# **CONNECTION ASSESSMENT & APPROVAL PROCESS**

**Preliminary Assessment Report – Final Version**  
Date: March 19, 2003

**Niagara-on-the-Lake Hydro Inc.**

**Build New 115-27.6kV Transformer Station**

Figure 1: ‘Niagara-on-the-Lake’ MTS #1

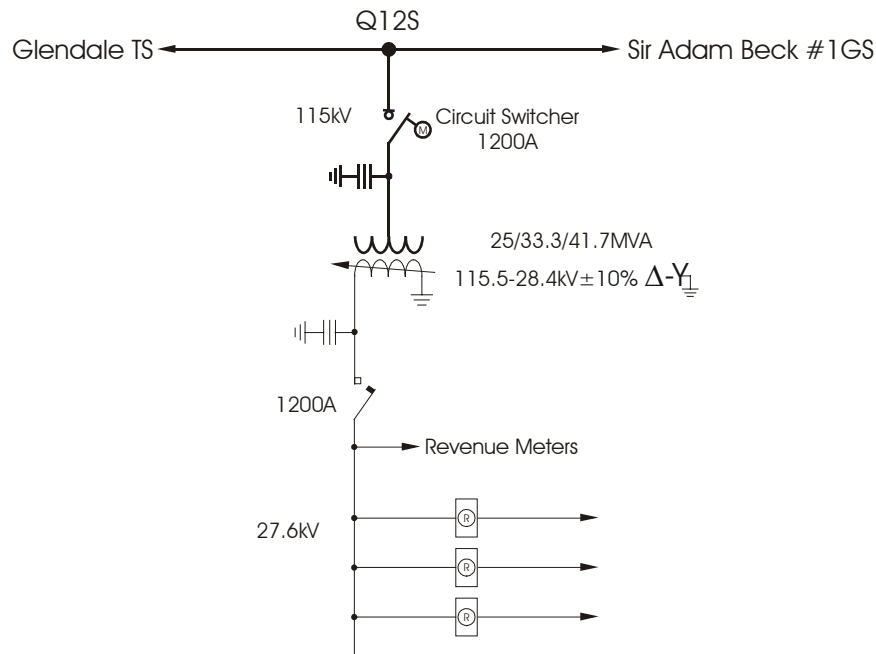
The new 138kV 1200A circuit switcher is capable of operating at a maximum voltage of 145kV and with a thermal rating of approximately 260MVA would be more than adequate for the proposed 42MVA transformer.

Based on information from Hydro One Networks Inc., the present maximum 115kV fault level at the Beck 1 GS is approximately 26kA. After allowing for the attenuating effect of the 8.5km of 115kV transmission line to the tapping point for the new station, the maximum fault interrupting duty that could be imposed on the new circuit-switcher is expected to be well within its rating of 25kA.

While the 25kA rating is considered to be adequate for the existing system conditions, changes to the system configuration could result in future fault levels exceeding this rating. Since the rating of the circuit-switcher is less than the 50kA rating specified in Appendix 2 of the Transmission System Code, then should the fault levels increase beyond the circuit-switcher's rating, Niagara-on-the-Lake Hydro Inc. would be required to implement one of the following options:

- ❖ Replace the circuit-switcher with one having a higher rating (if a suitable model is available).
- ❖ Replace the circuit-switcher with a circuit breaker having a higher rating.
- ❖ Use the circuit-switcher only for routine switching and not for fault clearance, and initiate transfer-tripping to trip 115kV circuit Q12S in the event of a transformer fault, or an uncleared low voltage fault.

Figure 2: Beck 1 - Decew Falls - Allanburg Corridor 115kV Transmission System

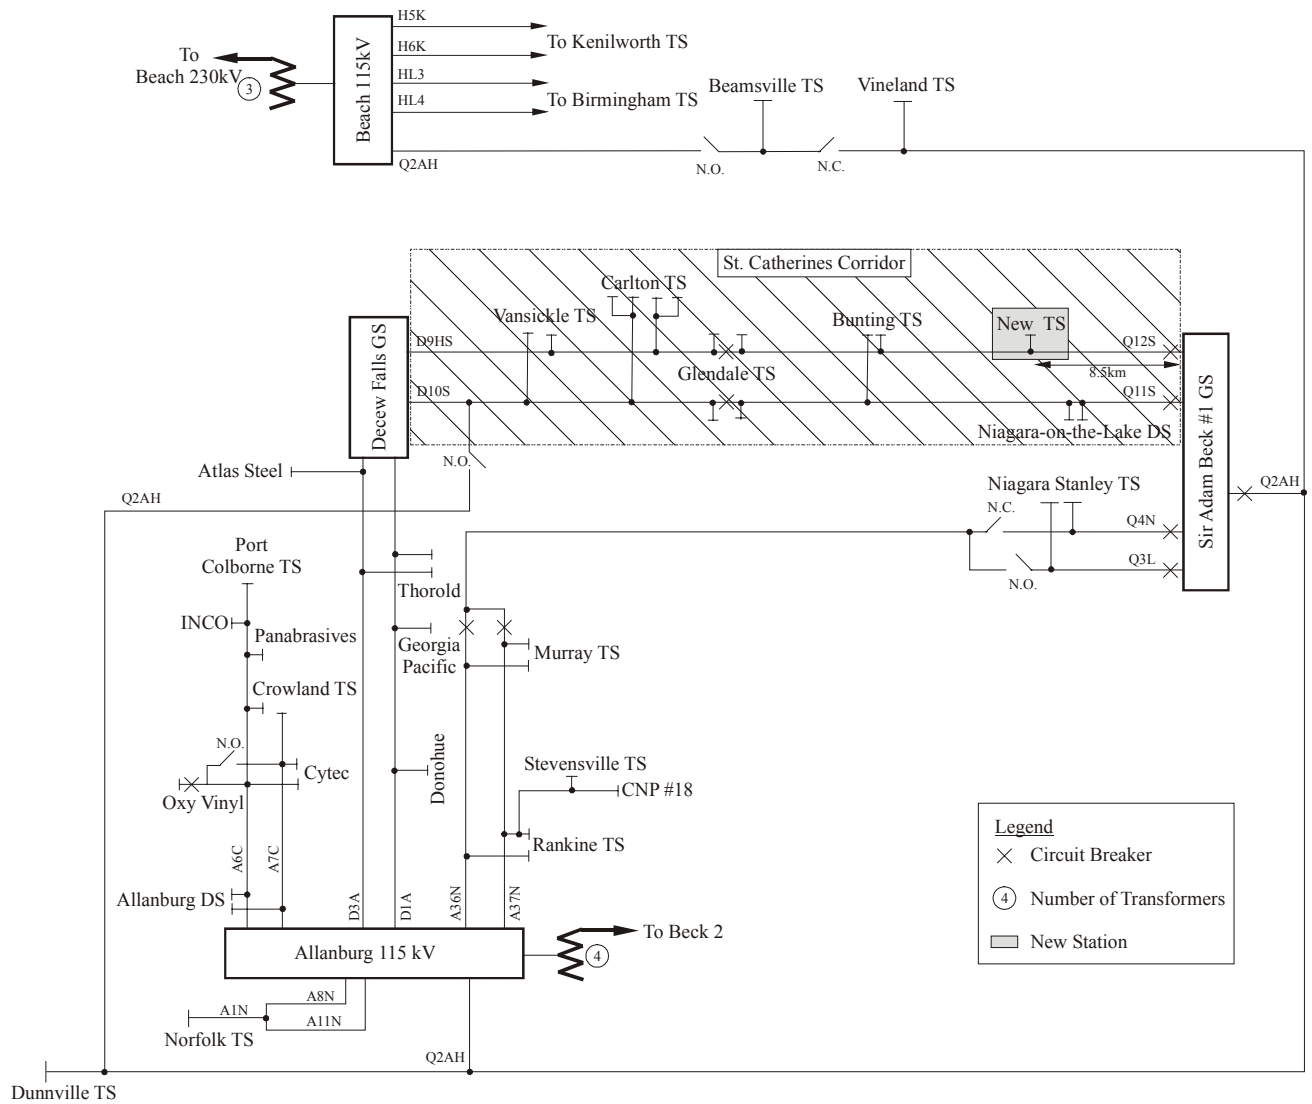
The new ‘Niagara-on-the-Lake’ MTS #1 will be located in an area defined as the Allanburg 115kV area, which is considered a local area such that only single contingencies will be respected. The new station will be connected to the Beck 1 GS to Glendale TS 115kV transmission circuit Q12S, which is a component of the 115kV system that is defined as the St. Catherines Corridor in the IMO-controlled grid. Figure 2 shows the 115kV transmission system in the Allanburg 115kV area.

Results of cases 1, 2, 6, and 7 show that the addition of the new ‘Niagara-on-the-Lake’ MTS #1 onto circuit Q12S and the subsequent load transfer from the existing Niagara-on-the-Lake DS will increase the power flow on circuit Q12S, while the flow on Q11S, which supplies the existing Niagara-on-the-Lake DS will decrease. These cases further demonstrate that power flows on the St. Catherines Corridor transmission circuits are very dependent on the output of the generating stations in the area. High output at Beck 1 GS will increase the flows on Q11S and Q12S and will reduce the flows on circuits D9HS and D10S. While high output at Decew Falls GS will have opposite effect on these circuits.

Result of Case 4 shows that with full output at Beck 1 GS, power flow on circuit Q12S will exceed the circuit continuous rating but within the 15-minute limited time rating (LTR) after the loss of circuit Q11S and the transfer of all the loads supplied from the existing Niagara-on-the-Lake DS to the new station. Control actions such as generation re-scheduling and the curtailment of post-contingency load transfer would have to be deployed to respect the emergency rating. This particular condition is the direct result of the proposed plan. With the existing system, the loss of circuit Q11S will also result in the loss of all the loads (about 30MW) supplied from the existing Niagara-on-the-Lake DS. The resulting power flow on Q12S will be less and well within its emergency rating.

Case 5 shows that with similar system conditions circuit Q11S will be loaded to about 90% of its emergency rating after the loss of Q12S and the transfer of loads between the existing DS and the new station.

Case 8 shows that with full output at Decew Falls GS and reduced output at Beck 1 GS, the loss of circuit D9HS will load the companion circuit D10S to about 94% of its emergency rating.

The above noted post contingency conditions can be alleviated by restricting load transfer or by re-scheduling the outputs at the generating stations in the area. However, it should be noted that those problems identified by Cases 5 and 8 would have occurred with the existing system and are not the results of the proposed plan.
